Lahontan Regional Water Quality Control Board

REVIEW OF CHROMIUM PLUME MAPS, THIRD QUARTER 2013 GROUNDWATER MONITORING REPORT AND AGREEMENT WITH NORTHERN INVESTIGATION CONCEPT, PACIFIC GAS AND ELECTRIC COMPANY, HINKLEY, SAN BERNARDINO COUNTY (CLEANUP AND ABATEMENT ORDER NO. R6V-2008-0002A4) WDID 6B369107001

REQUEST FOR AN ACTION PLAN AND MORE INFORMATION IN REPORTS REQUIRED BY CLEANUP AND ABATEMENT ORDER NO. R6V-2008-0002 AND INVESTIGATIVE ORDER R6V-2013-0041

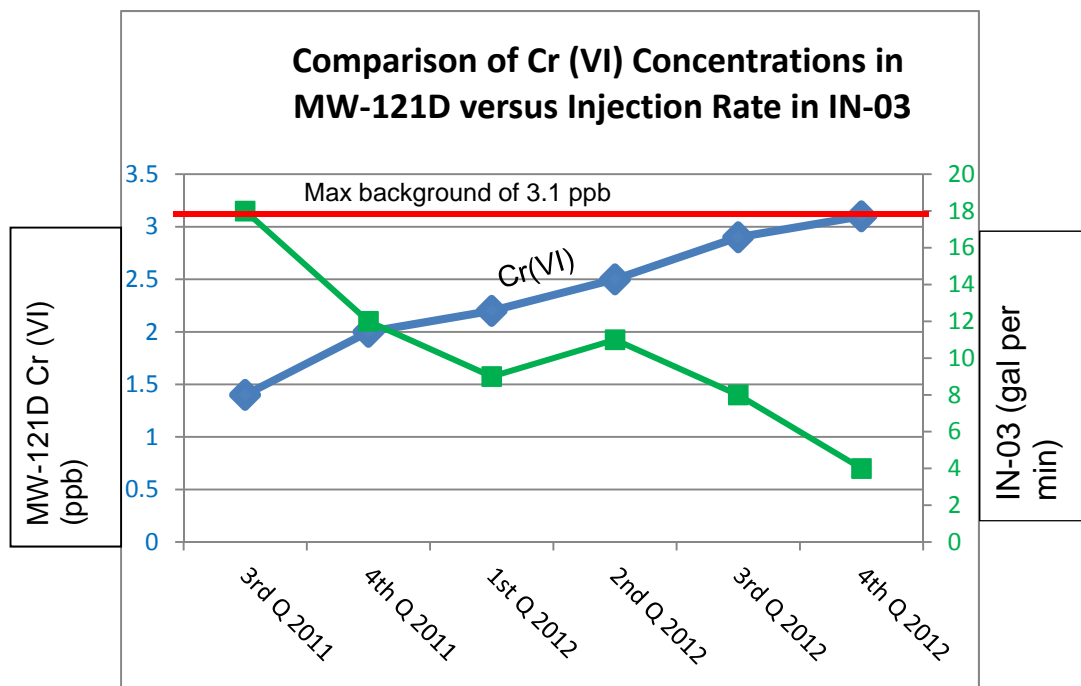
c. Amend Table 2-11 to show the total calculation of all columns for the quarter being reported.

The revised Table 2-11 contained in Attachment 1 to the report was not amended to include the total calculations during first quarter 2013 for four columns: total days in period pumping, % of period actively pumping, average injection rate when pumping, and average injection rate for period.
